**CENTER FOR DRUG EVALUATION AND
RESEARCH**

761367Orig1s000

DIVISION OF DRUG DELIVERY, GENERAL HOSPITAL & HUMAN FACTORS
INTERCENTER CONSULT MEMORANDUM – PRE-FILLED SYRINGES

Submission Information	
Submission Number	BLA761367
Sponsor	CSL Behring LLC
Drug/Biologic	Garadacimab (CSL 312)
Indications for Use	Prophylaxis to prevent attacks of hereditary angioedema (HAE) in patients 12 years and older
Device Constituent	Pre-Filled Syringe with NSD and Autoinjector
Related Files	ICC2300938 – complete review
	ICC2300621- Facilities review. ICC2400990 – meeting request to discuss CR letter comment

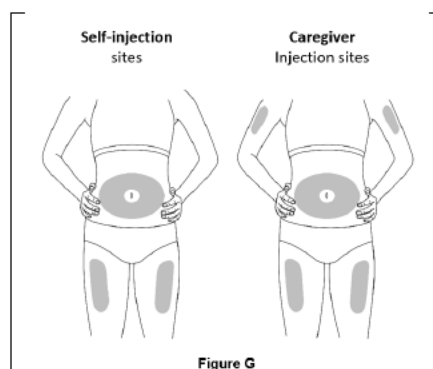
Risk associated with errors associated with this task: Underdose and loss of efficacy.				
Relevant RCA/Subjective Feedback: • Confusion with IFU: Based on the Figure H (see image below) one participant thought that the IFU lists the arm for self-injection. • Negative transfer: participants have experience with their HCP injecting in the arm, including the deltoid, or they have learned from school to inject in the arm.

Based on subjective feedback from the prefilled HF study (one participant saw the arm highlighted in Figure H and believed that they could self-inject there), as well as subjective feedback from the autoinjector "Summative Study #1" (seven participants (5 untrained and 2 trained) stated that they could inject in the arm; these errors were due to confusion with the IFU image similar to Figure H), we identified that Figure H should be revised using the same modifications the Applicant used for Figure G in the autoinjector IFU (see below and Appendix D for more information). **We provide our recommendation in Table A to address this concern.** We have determined that this change can be implemented without submitting additional HF validation testing data for Agency review.

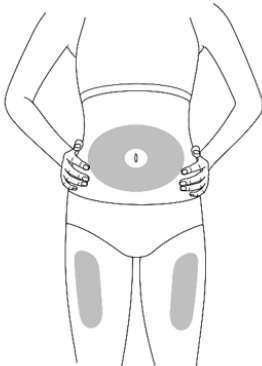
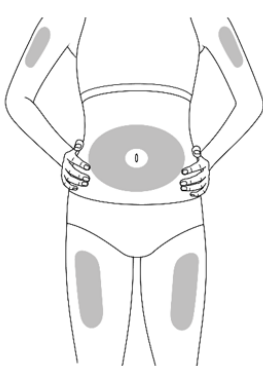
button that they continuously tried to “push”, rather than pushing firmly against the skin to activate the autoinjector. A right-handed trained, injection experienced caregiver in the second simulated use scenario held the autoinjector at an approximately 45° angle. Although the participant knew to inject at a 90° angle and was able to do so during the first simulated use scenario, they used their left hand due to having a steel bar in their right hand. This combined with not properly adjusting their chair in a way that they could push the autoinjector led to a 45° angle.

- o Summative study #2: One HCP depressed the device at about a 45° angle, but then moved the autoinjector to a 90° angle, as that is how they administer subcutaneous injections.

We note that the URRAs states not pushing the needle shield at a 90° angle may lead to: intradermal dose which may lead to pain, discomfort, itching, swelling, and redness and blood vessel (vein, artery) dose which, may lead to bleeding, but no clinical relevance. Based on the risks, mitigations, and overall user interface, we have no recommendations at this time.
